# **Intel® 82599 10 GbE Controller**

**Specification Update**

*January 2020*

Revision 3.9  
331521-008

Figure 1-1. Example with Identifying Marks

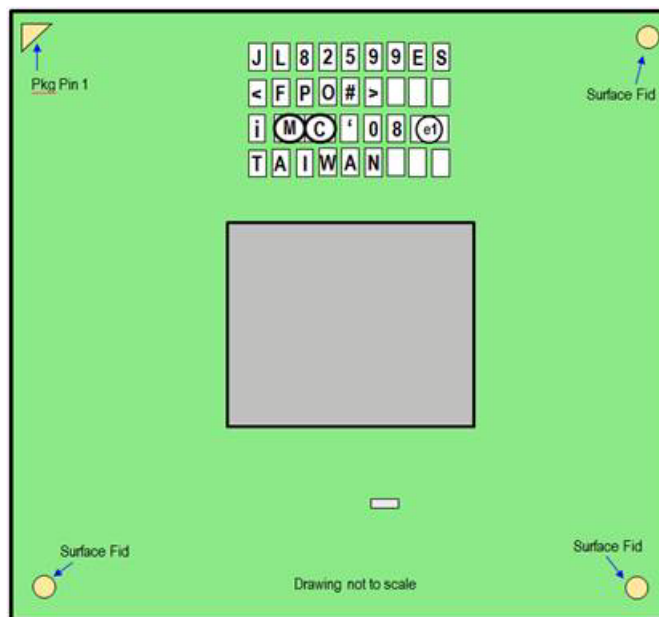
3.1	March 27, 2014	<b>Miscellaneous Updates:</b> <ul style="list-style-type: none"><li>Marking Diagram in Figure 1-1 updated to reflect new substrate.</li></ul>

Intel incorporates an internal designator of a dash mark (–) that is visible on the die side of the package, and is approximately 300 x 1000 mm in size. The actual location may differ from the example pictured. This mark is intended for internal purposes only and does not affect the product performance as designed. The customer's visual inspection system should be updated to allow for this feature.
